Kansas Department of Agriculture  
 Division of Water Resources  
**CHANGE: P/U WORKSHEET**

RE: Change the Place of Use, File Nos; 1050 3838 12561  
27888

**SUMMARY ORDER APPROVING APPLICATION FOR CHANGE AND IMPOSING CONDITIONS**

# GMD3 Change Review

# Change in Place of Use: WR 3,838

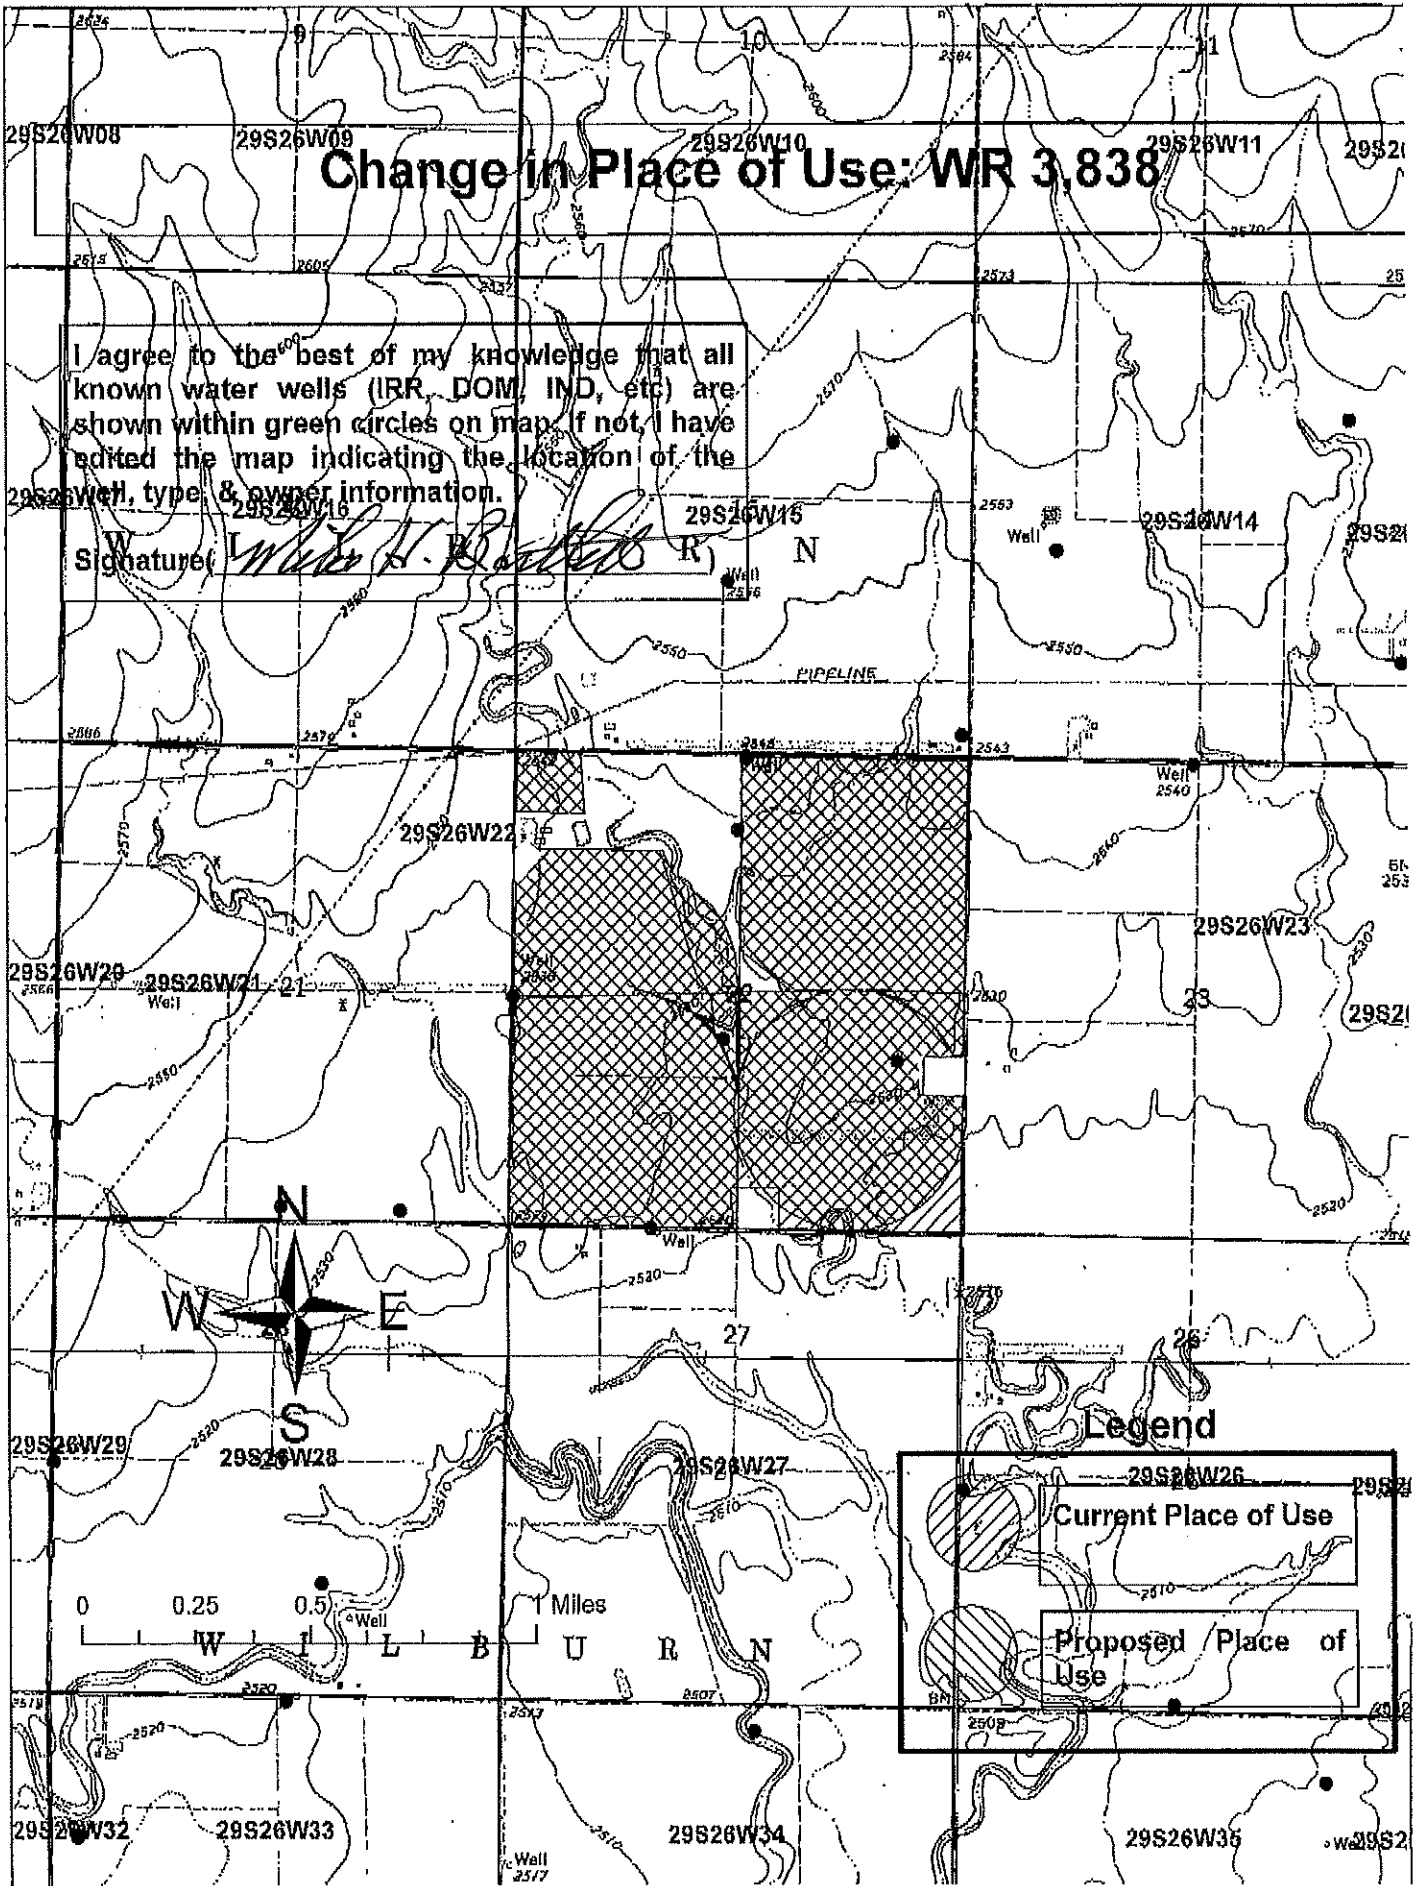
I agree to the best of my knowledge that all known water wells (IRR, DOM, IND, etc) are shown within green circles on map. If not, I have edited the map indicating the location of the well, type, & owner information.

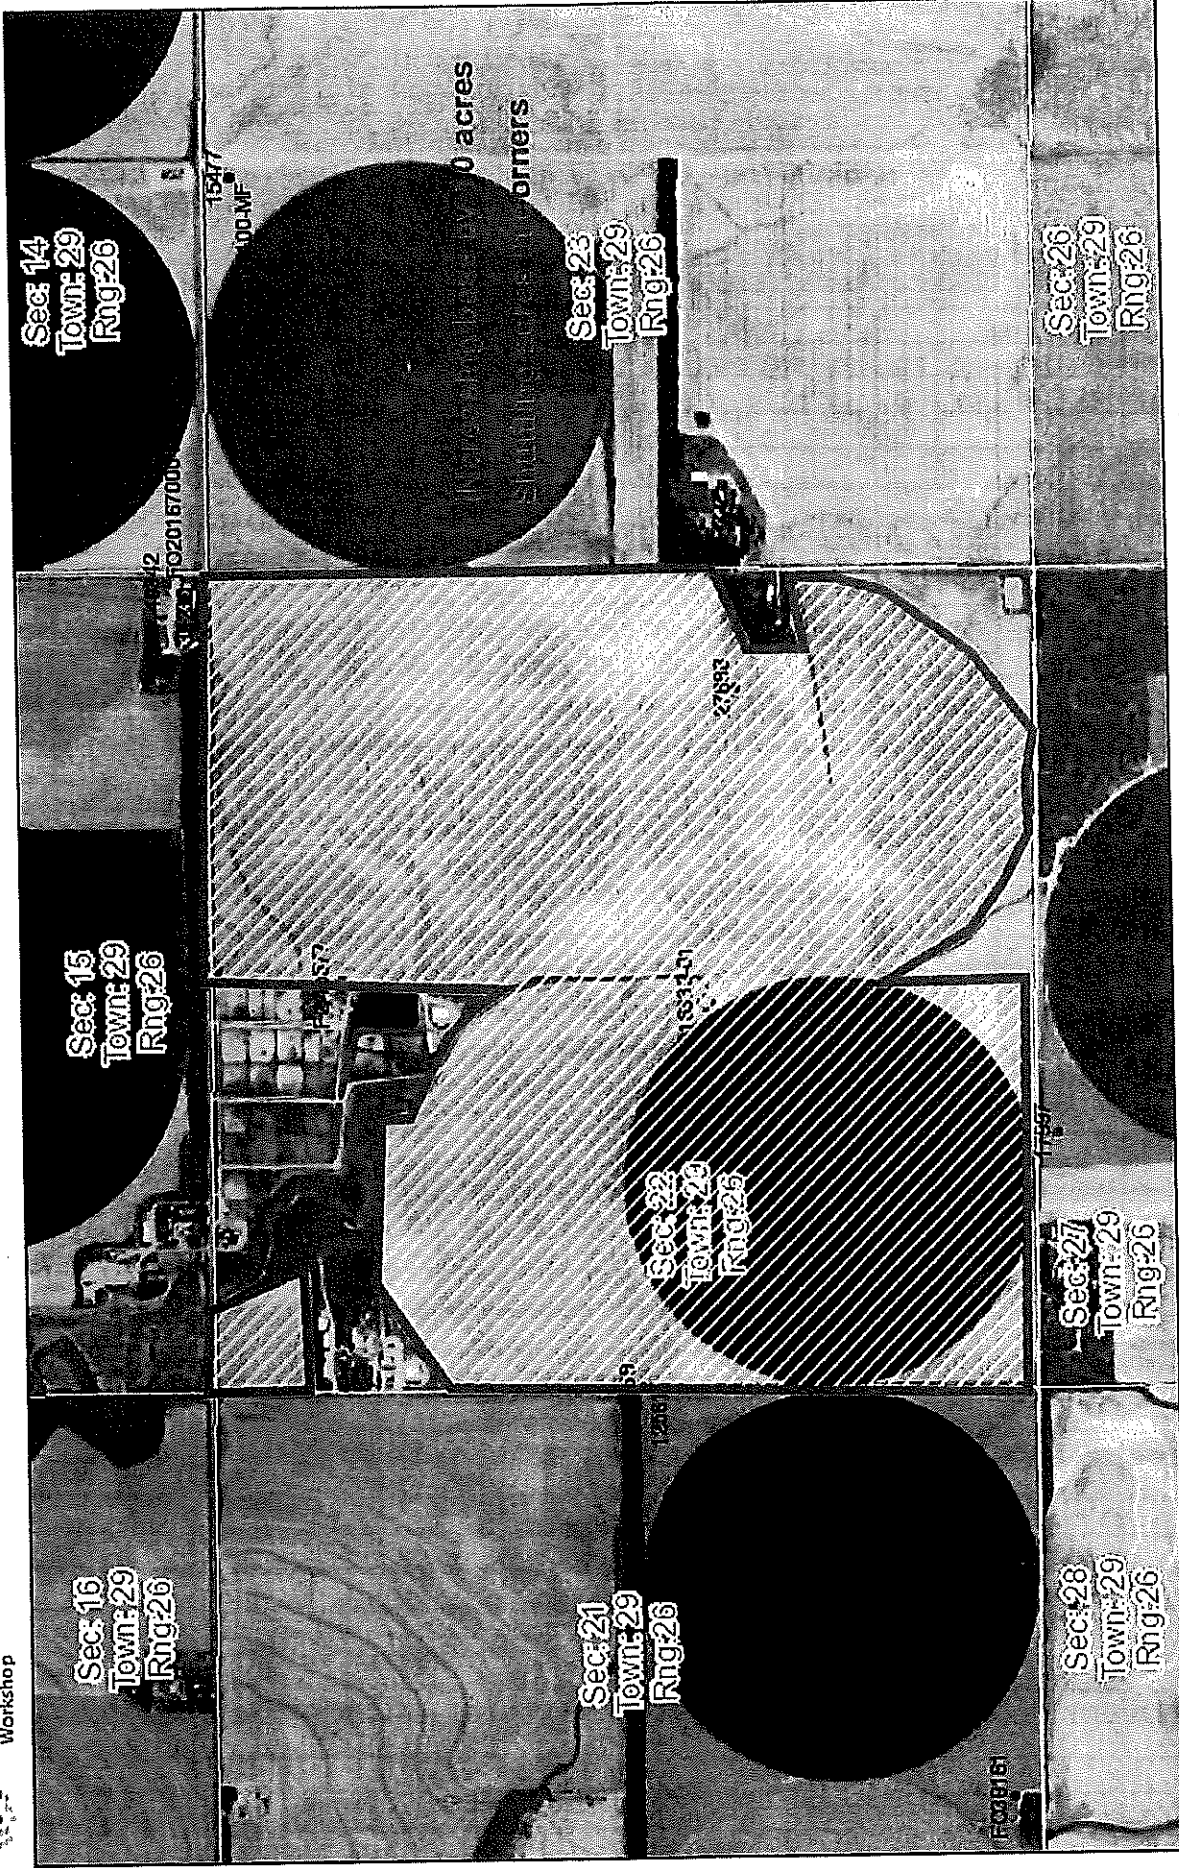
**Current acres: 529**

**Proposed acres: 534 (10 more than base)**

**WR 27888 brings in limitation of 889AF when combined with all WRs**

Final Recommendation: After review of all available information, it appears the current area rules are met. Staff therefore recommends approval of the applications.
